Technical Note

512Mb Mobile DDR: 95nm to 78nm Product Transition Guide

Figure 1: Status Read Register

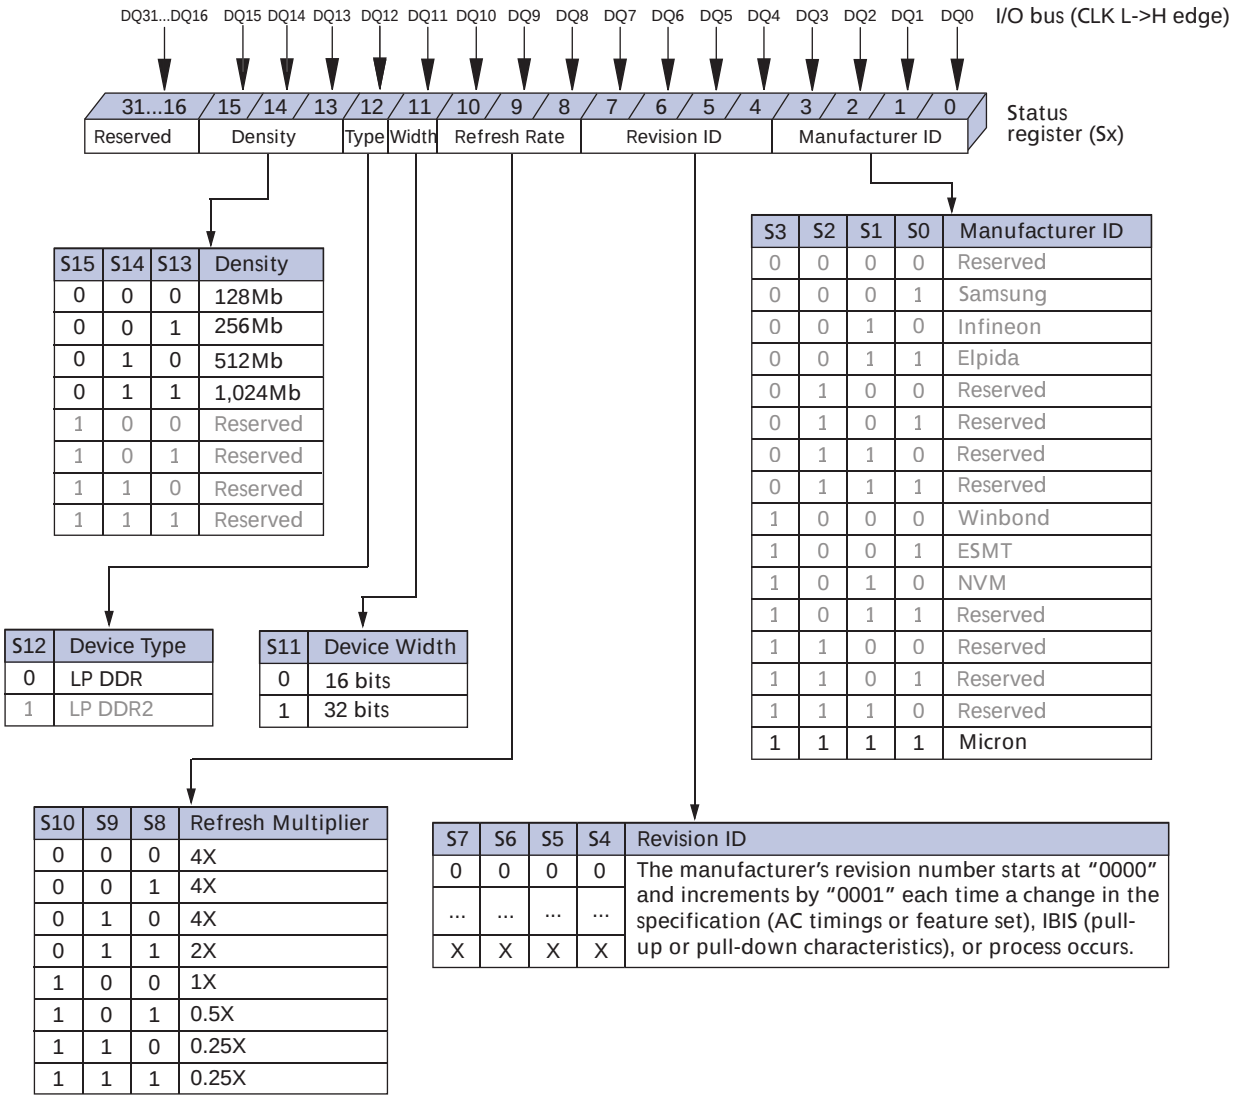
The status read register (SRR) has been added to the 78nm product. It is used to read the manufacturer ID, revision ID, refresh multiplier, width, type, and density of the Mobile SDRAM, as shown in Figure 1 on page 2. The information made available from this read-only register can assist the component package manufacturer. It can also be useful for product operation in the target application. The SRR is read via the LOAD MODE REGISTER command with BA0 = 1 and BA1 = 0. Consult the 78nm product data sheet for a full description of the SRR operation.

Figure 3: New 78nm, x16, 8 x 9mm, 60-ball VFBGA

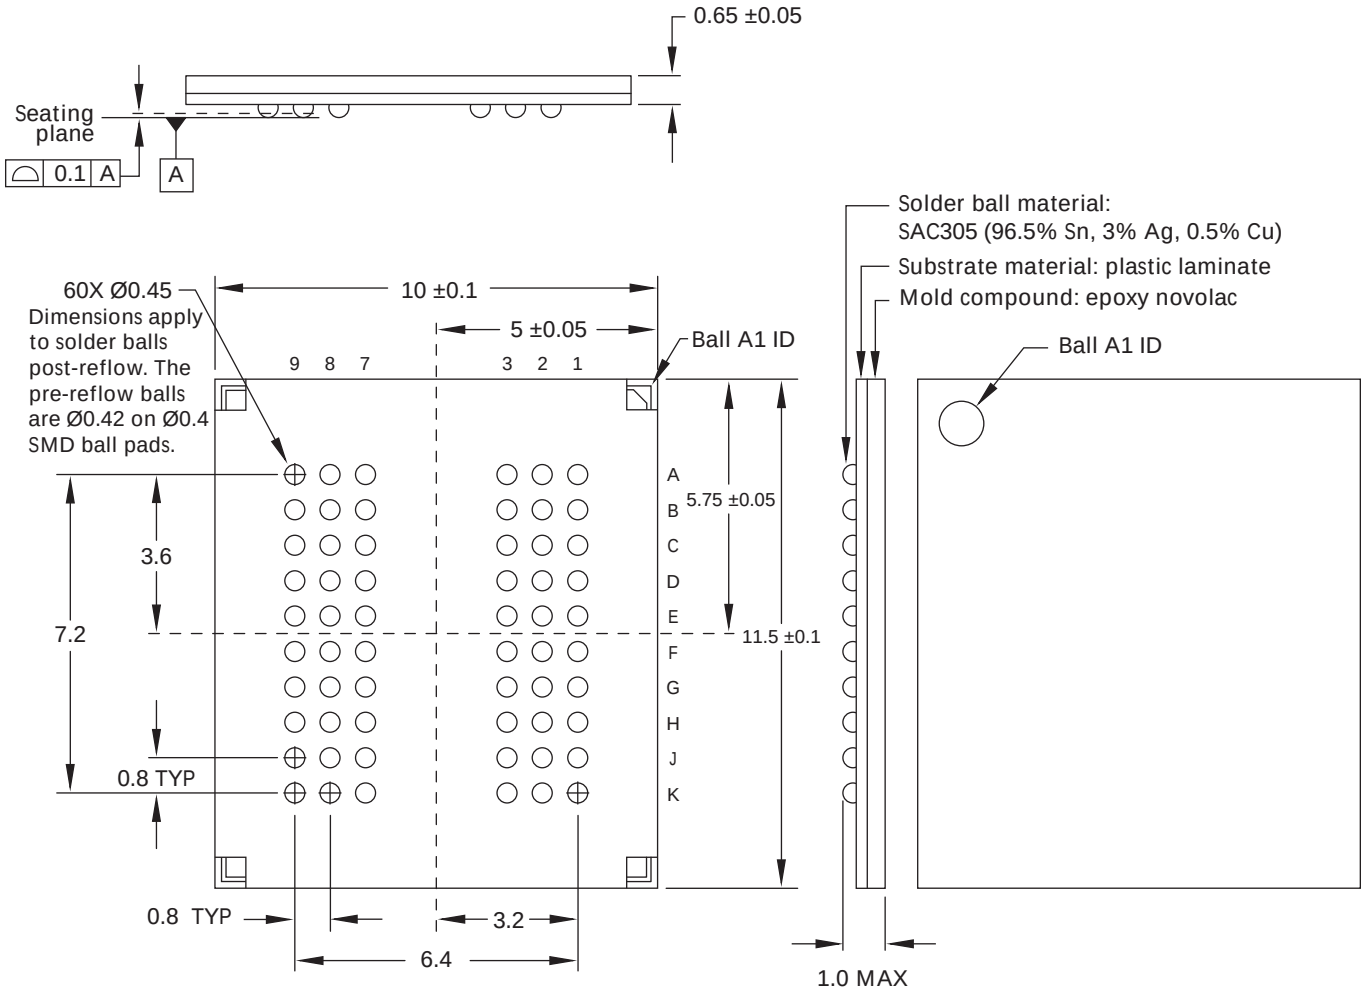
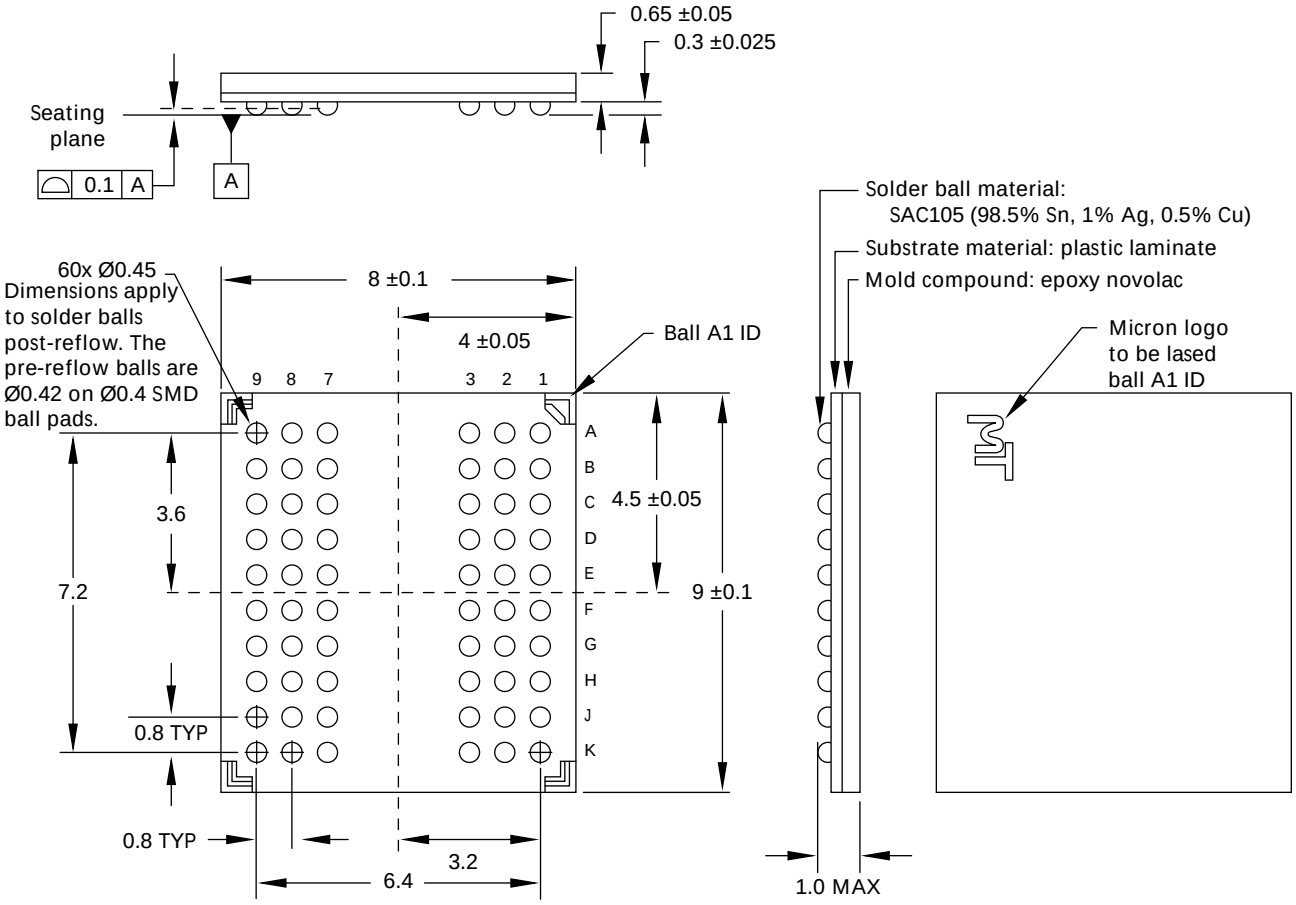
The 95nm, x16 and x32 products use SAC305 package solder ball composition, as shown in Figure 2.

Both the x16 (60-ball) and the x32 (90-ball) packages for the 78nm product use SAC105 solder ball composition. This aligns with the industry trend toward SAC105 composition for enhanced drop test performance. The surface mount conditions for SAC105 are the same as for SAC305.

In addition, the 78nm, x16 product offers a smaller, 8mm x 9mm package outline to conserve application board space, as shown in Figure 3 on page 4. The ball assignments for both 78nm packages are JEDEC compliant.
